March 16, 2022

Re: Comments on the Draft EIR for the Idaho-Maryland Mine Project

From: David M. Chambers, Ph.D., P. Geop.

EIR Figure 3-14 (Rise Grass Valley)

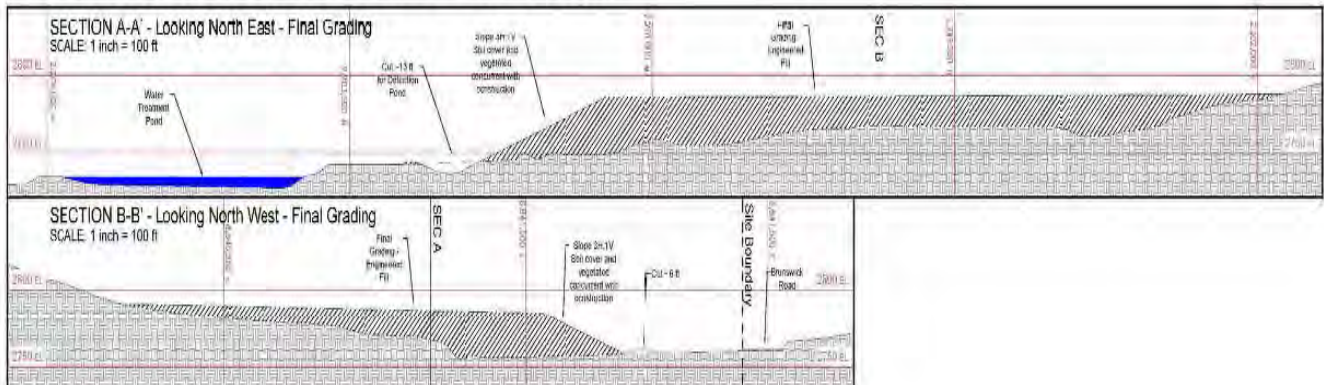
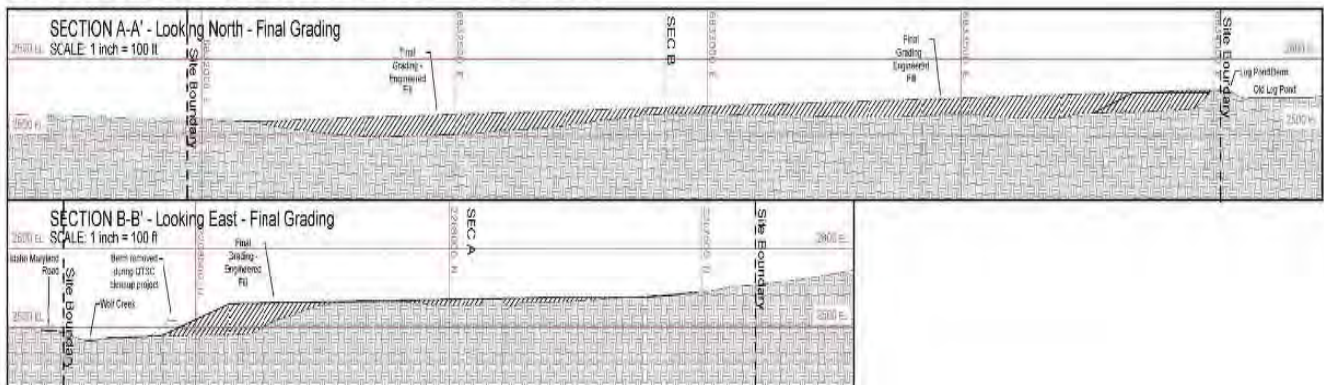
It is stated in the EIR that, “*Engineered fill would continue to be placed, graded, and compacted in a series of lifts ...*” The only drawings of the cross sections of the waste facilities in the EIR are from Rise Grass Valley, not an engineering company, and seems to show the mine waste being deposited as end-dump layers that cannot be compacted to generate further stability, not horizontally-deposited layers that could be compacted.

The new mine waste will be placed on top of portions of existing mine waste, which could provide a plane of weakness that could provide an additional failure plane for the significant weight of rock that will be placed on top of it. The Brunswick facility is projected to be up to 90 feet in height, and the Centennial facility up to 70 feet high.

There is no technical report to provide the detail needed to evaluate the geotechnical viability and safety of these facilities. The potential for this waste to fail under static or seismic loading needs to be professionally evaluated by a qualified engineering contractor. It would be inappropriate to issue a permit for the construction of these waste facilities without proper engineering analyses. To illustrate what could happen, the picture in Photo 1 comes from a waste rock pile at a Nevada mine that failed due to inadequate engineering. While not catastrophic, such failures can cause significant environmental and economic damage.

Figure 2-3, from Predictions of Groundwater Inflows to the Underground Mine Workings at the Idaho-Maryland Mine, ITASCA, November 2020

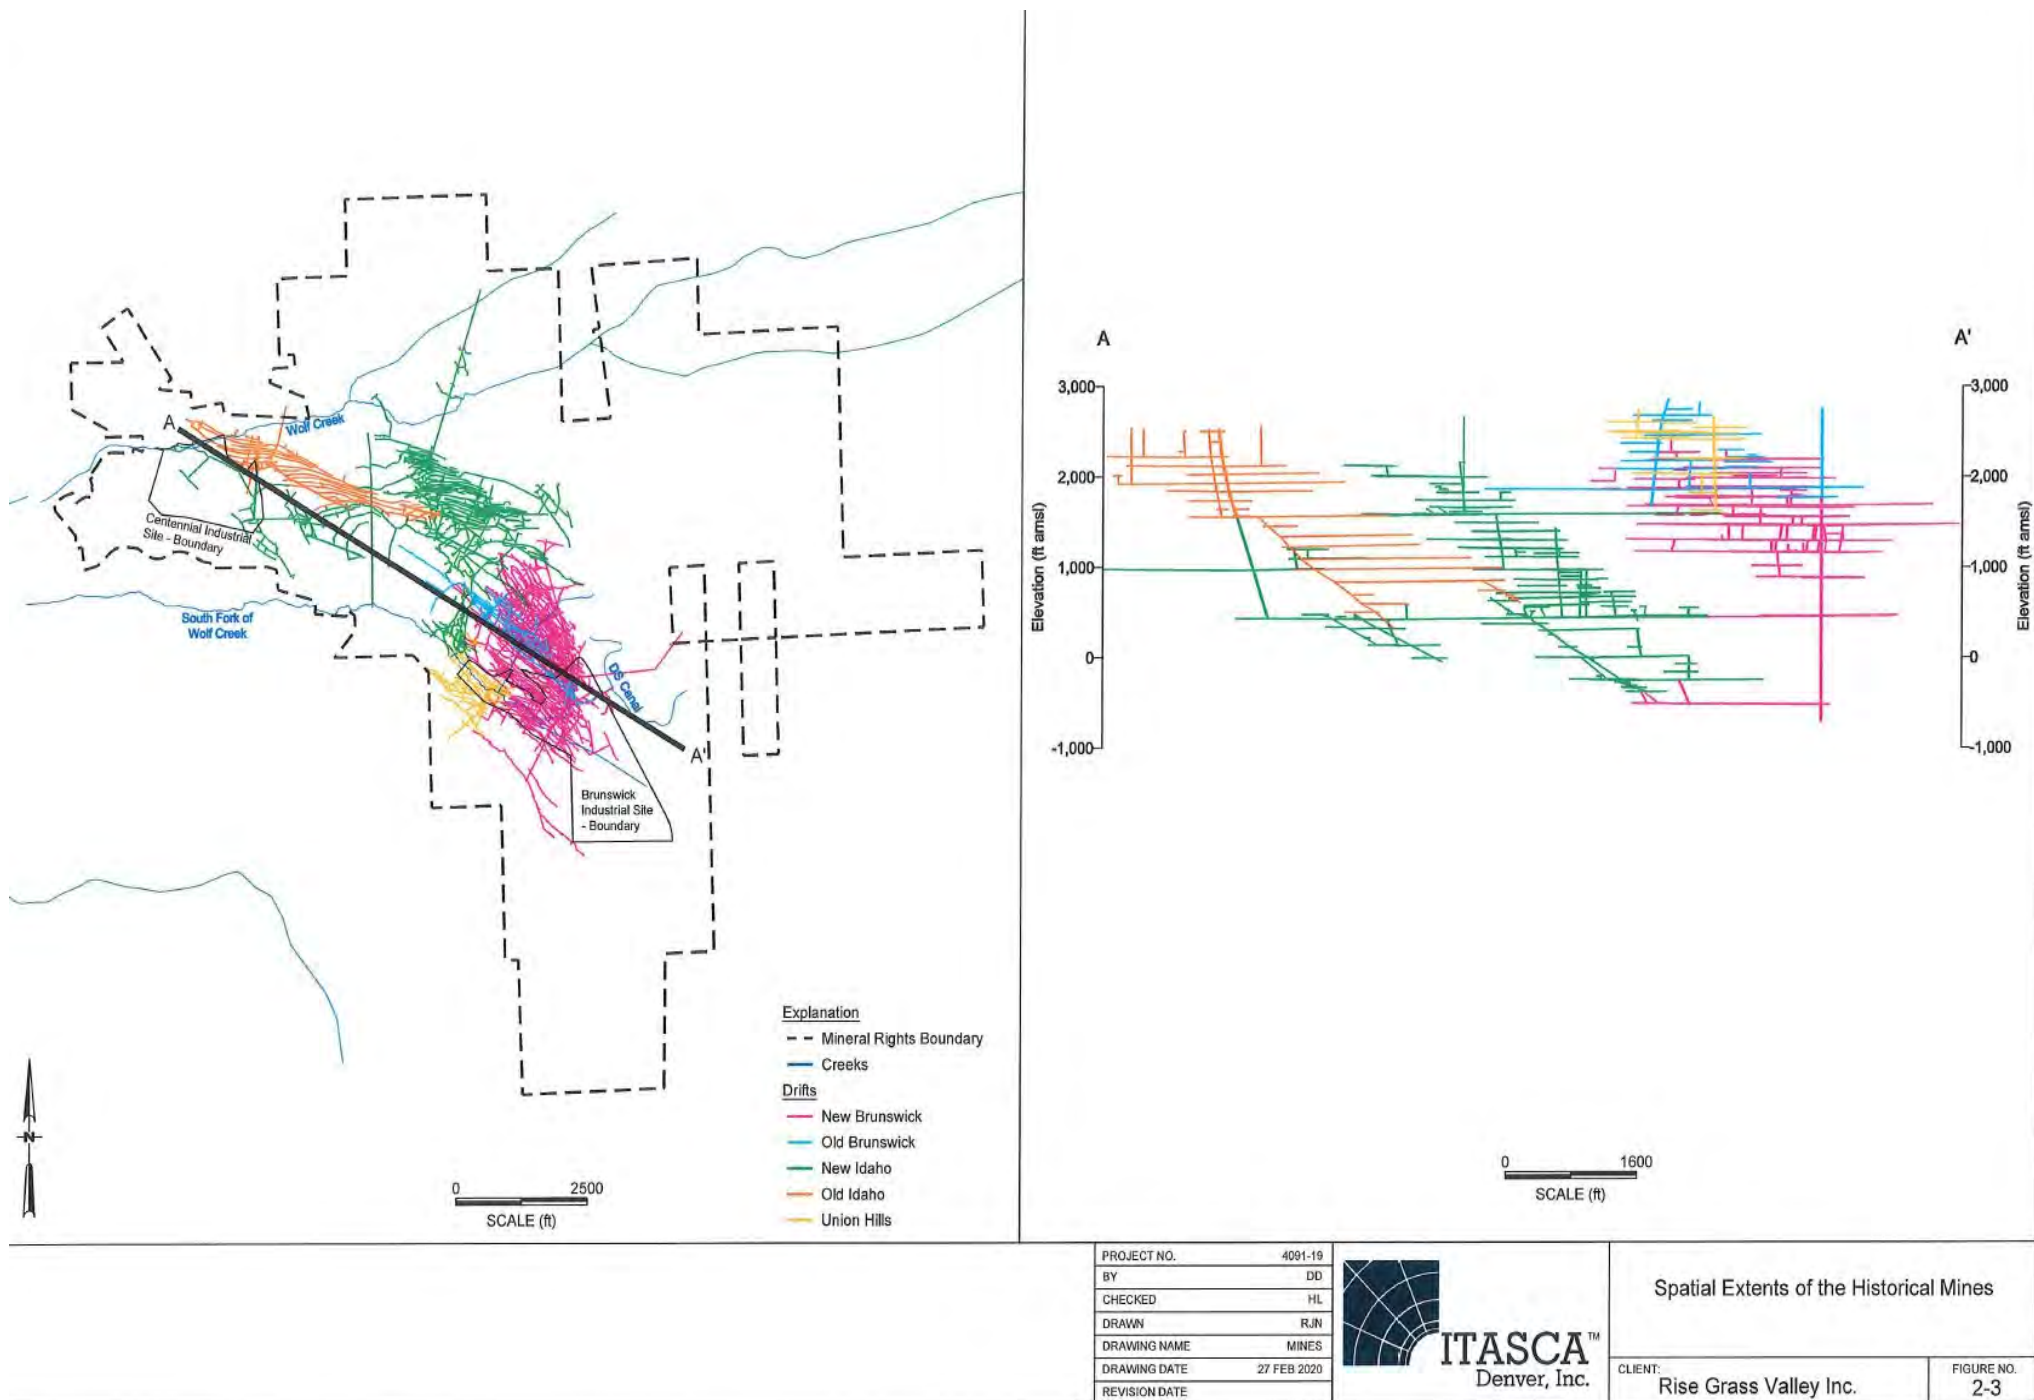
There is no discussion in the EIR of the potential impacts for the Idaho-Maryland Mine if flooding were to occur during mining. From ITASCA Figure 2-3 (attached as the last page of this document), it can be seen there are extensive abandoned mine working above and adjacent to the Idaho-Maryland mine that will remain flooded after the Idaho-Maryland is dewatered.

If a conduit between these two mine were to open, for instance due to the widening of a fracture related to blasting vibrations or a seismic event, the flood of water into the Idaho-Maryland could be rapid and catastrophic for anyone working in the mine.

This issue must be thoroughly addressed before anyone is permitted to enter the dewatered mine.
